# Caddens Hill Subdivision Stages 8 to 10 Pre-Construction Concept Design Road Safety Audit

Client: Legacy Property

Version: 02

Date: 11 November 2021

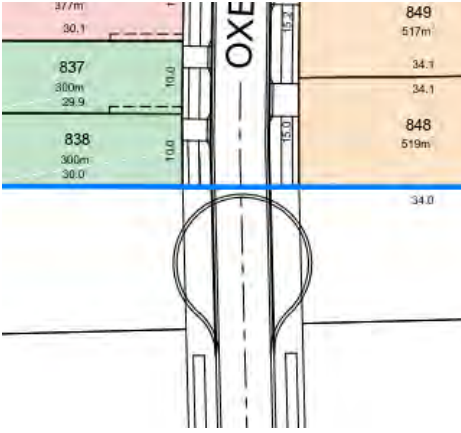
Item No.	Location / type	Descriptions of Findings	Design/ Photo	Likelihood	Severity	Risk Rating	Designer Response
1.	Intersections of Starline Road / Oxen Way  and  Starline Road / Ghera Road	Closely spaced (about 16m) T-intersections can result in minor crashes as a result of vehicles manoeuvring through the intersections.  Vehicles tend to cut corners crossing centrelines or drivers not sighting vehicles turning from side streets resulting in two car crashes.		Occasional	Moderate	Medium	The layout adopted provides limited opportunity to remove this intersection configuration. The number of vehicles (per day) likely to be in conflict is not considered to be high, with only a limited number of dwellings along the north-eastern end of Ghera Road and the adjacent road (Lots 860-862, 856-859, and 912-919) likely to make a right turn at this Ghera/Starline intersection. Other users in further along Ghera and the adjacent road are likely to proceed west and then south along Ghera to exit the area. No change in design proposed.

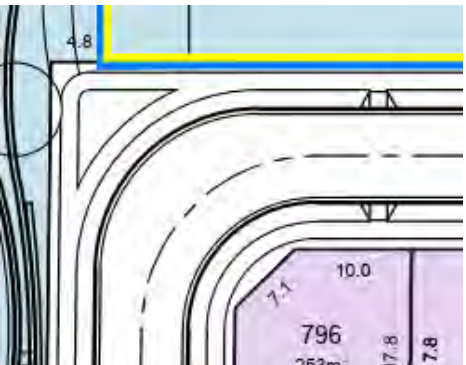
Item No.	Location / type	Descriptions of Findings	Design/ Photo	Likelihood	Severity	Risk Rating	Designer Response
4	Ghera Road	Plans do not show parking restrictions. As there are 90 degree bends in Ghera Road. It is possible that vehicles may park on the bends restricting access for garbage trucks or other trucks accessing properties.		Improbable	Moderate	Low	Signposting "No Parking" will be considered in conjunction with Council.
